29 NEW END
NW3 1JD

DESIGN DEVELOPMENT AMENDMENT SUBMISSION
AUGUST 2016
REVISION 1 31/08/2016

KSR ARCHITECTS LLP
4 Green and Street
London NW1 0ND

2.1 LOWER GROUND FLOOR PLAN AMENDMENTS

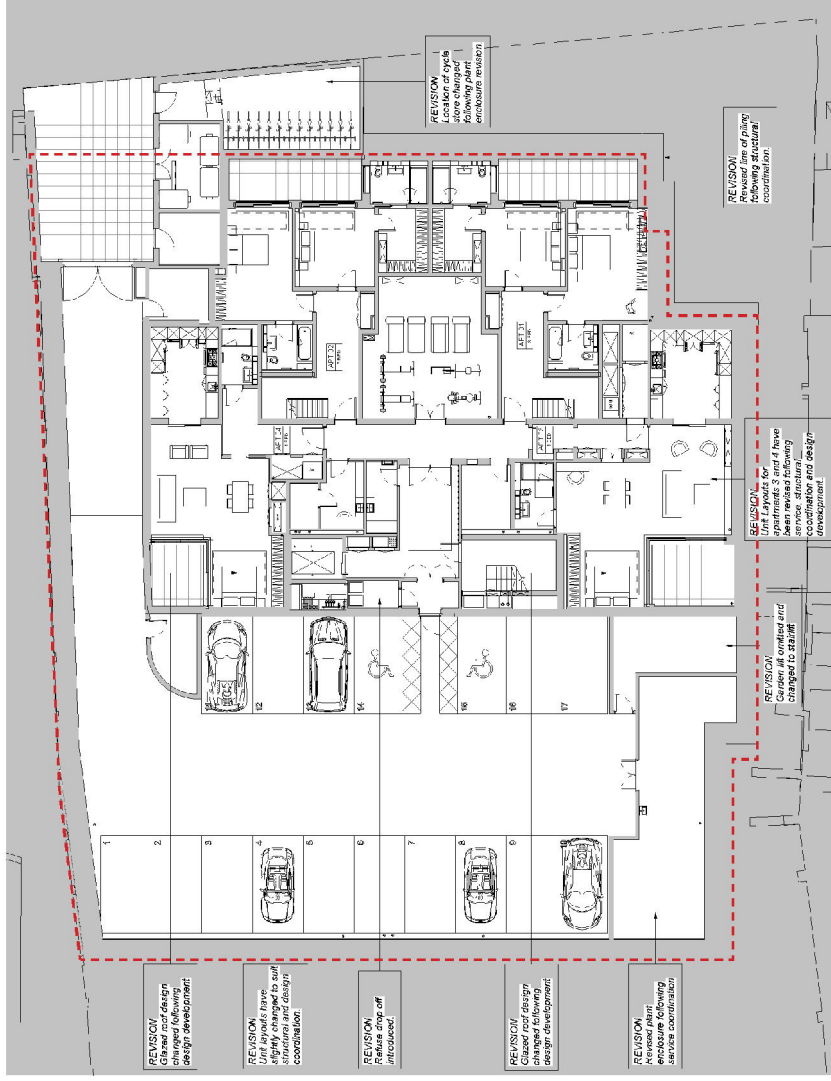
1. Following services coordination on the plant enclosure was enlarged
2. Revised line of piling.
3. Location of the cycle store was revised following the plant enclosure revision.
4. A refuse drop-off has been provided. There has been no change to the refuse pick up location.
5. Unit layouts for apartments 1, 2, 3 and 4 have been revised following service and structural coordination and design development. The changes do not alter the external road frontage of the facade.
6. Garden lift omitted and changed to stair lift.
7. Changes to glazed extension to apartments 3 and 4.

2.3 FIRST FLOOR PLAN AMENDMENTS

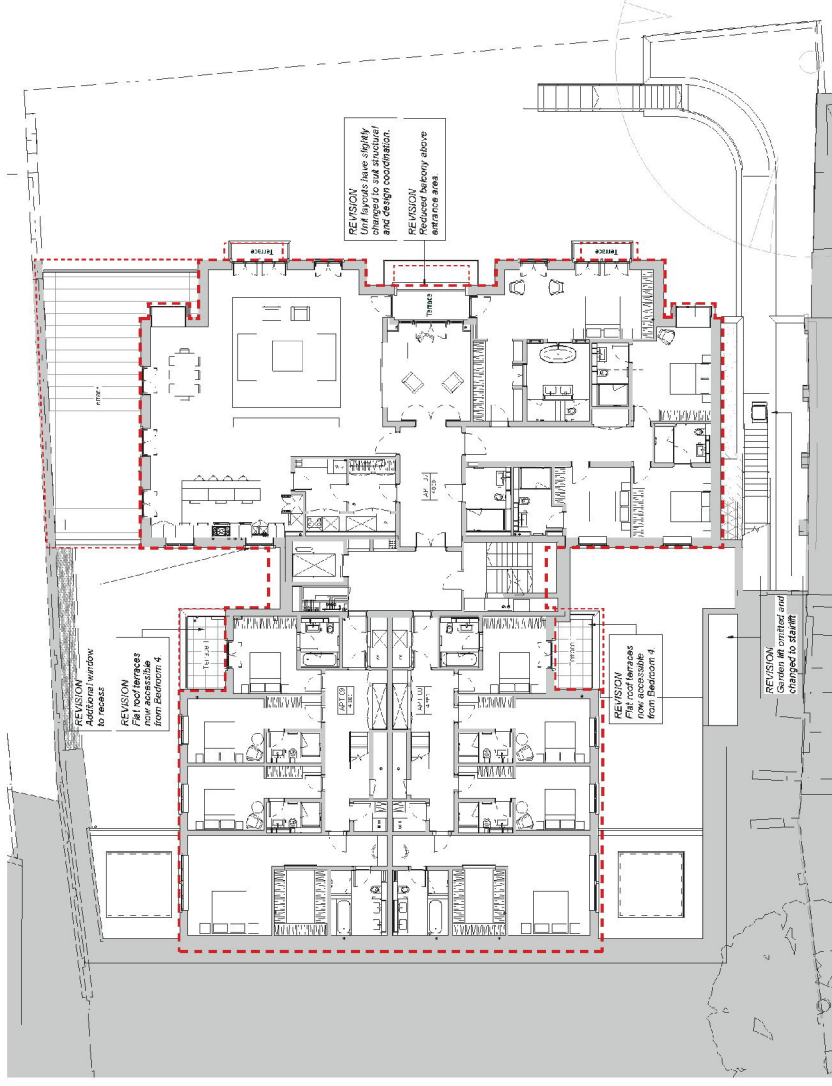
1. Additional window added into recess.
2. Flat roof terraces now accessible from Bedroom 4 in apartment 8 and 9.
3. Garden lift omitted and changed to stair lift.
4. Revision to balcony above entrance area.
5. Unit layouts for apartments 7, 8 and 9 have been revised following service and structural coordination and design development. The changes do not alter the external reading of the facade.

2.4 SECOND FLOOR PLAN AMENDMENTS

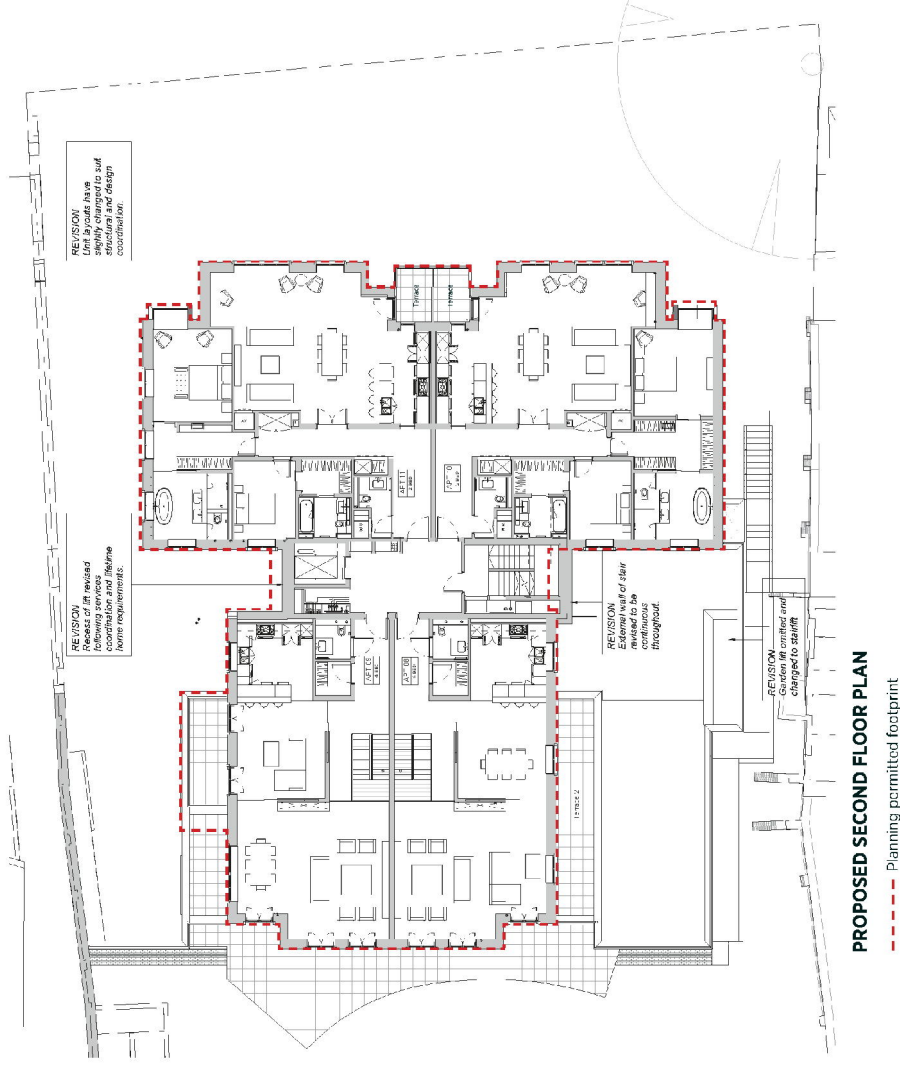
1. Recess of lift revised.
2. External wall of stair revised.
3. Garden lift omitted and changed to stair lift.
4. Unit layouts for apartments 8, 9, 10 and 11 have been revised following service and structural coordination and design development. Minor alterations to window locations to coordinate plan changes.

2.5 THIRD FLOOR PLAN AMENDMENTS

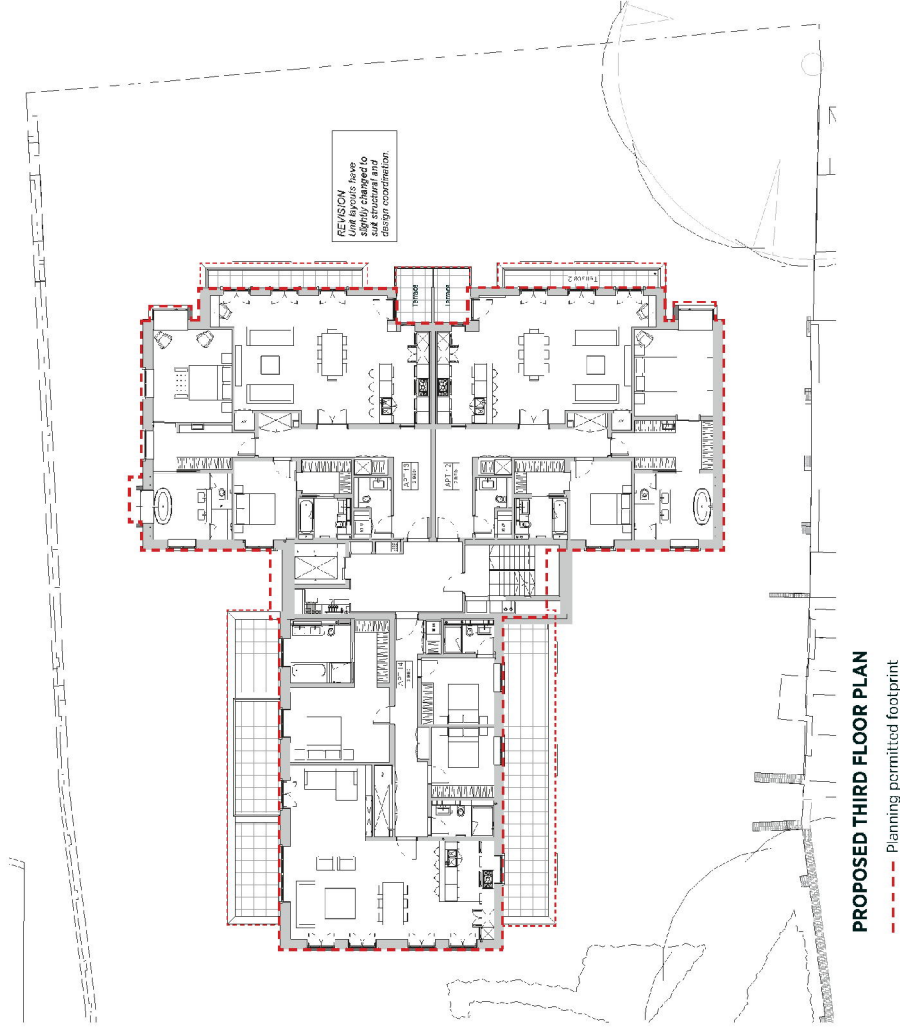
1. Unit layouts for apartments 12, 13 and 14 have been revised following service and structural coordination and design development. Minor alterations to window locations to coordinate plan changes.

2.6 FOURTH FLOOR PLAN AMENDMENTS

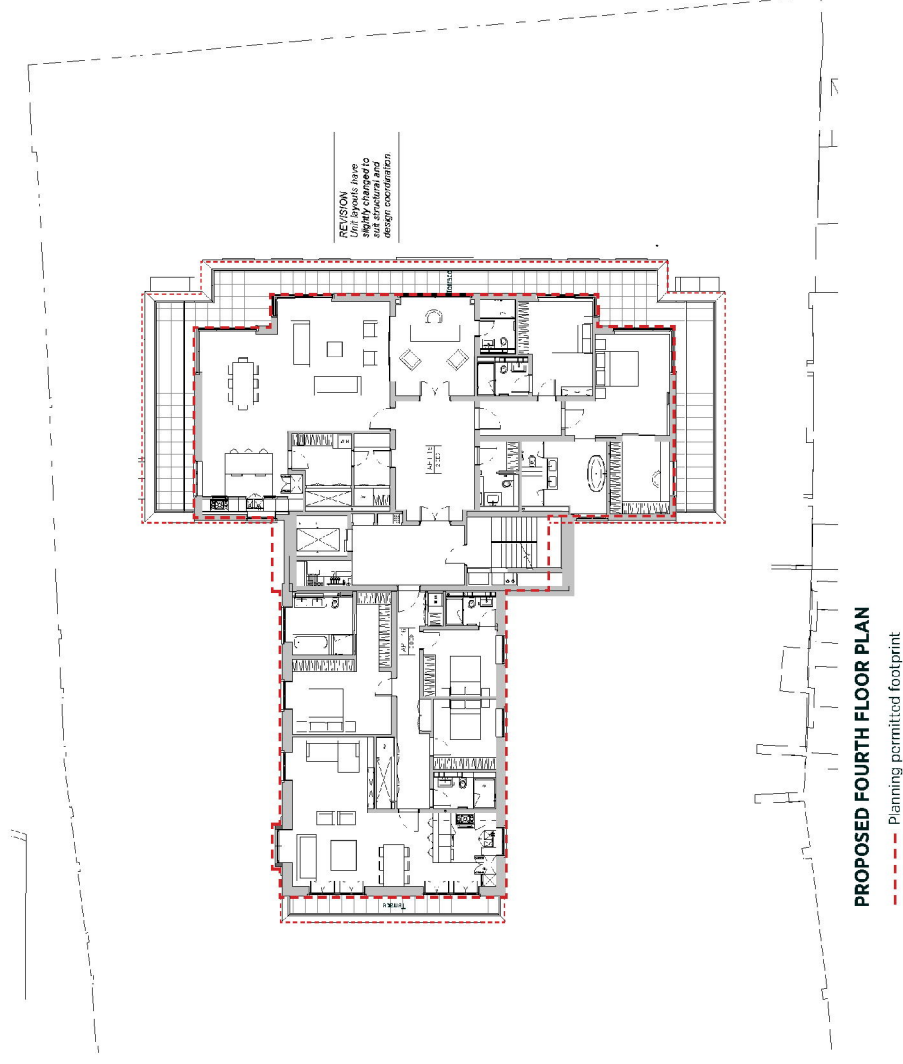
1. Unit layouts for apartments 15 and 16 have been revised following service and structural coordination and design development. Minor alterations to window locations to coordinate plan changes.

2.7 FIFTH FLOOR PLAN AMENDMENTS

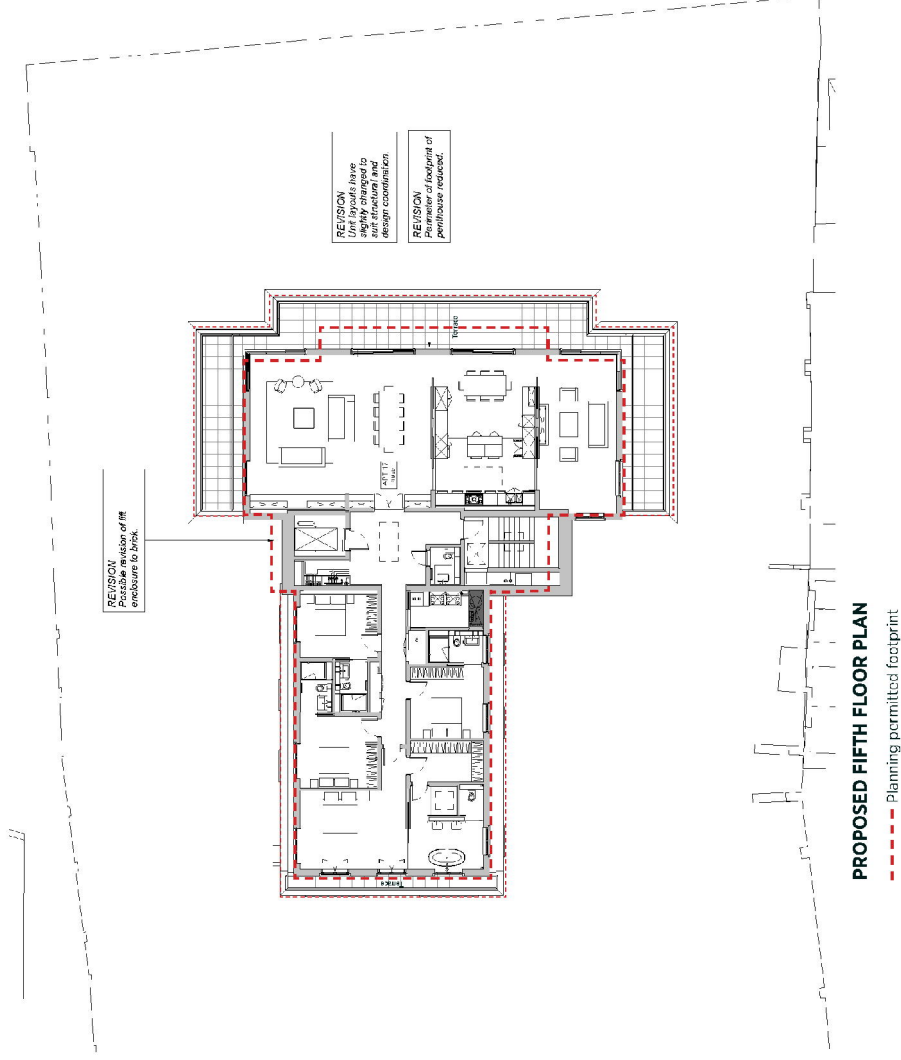
1. Unit layouts for apartment 17 have been revised following service and structural coordination and design development. Minor alterations to window locations to coordinate plan changes.
2. Front facade altered to increase terrace area.
3. Possible revision of lift enclosure to brick.

2.8 ROOF PLAN AMENDMENTS

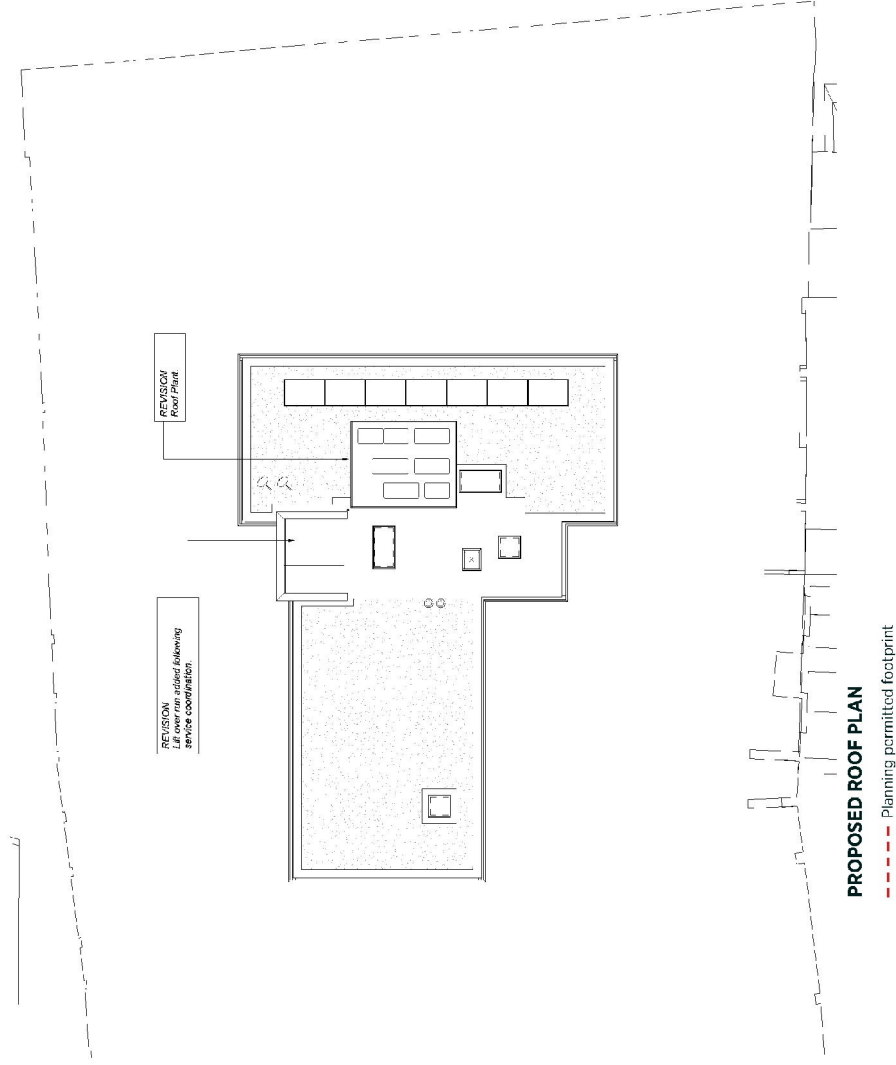
1. Lift over run added.
2. Roof plant enclosure enlarged and relocated to allow services coordination.
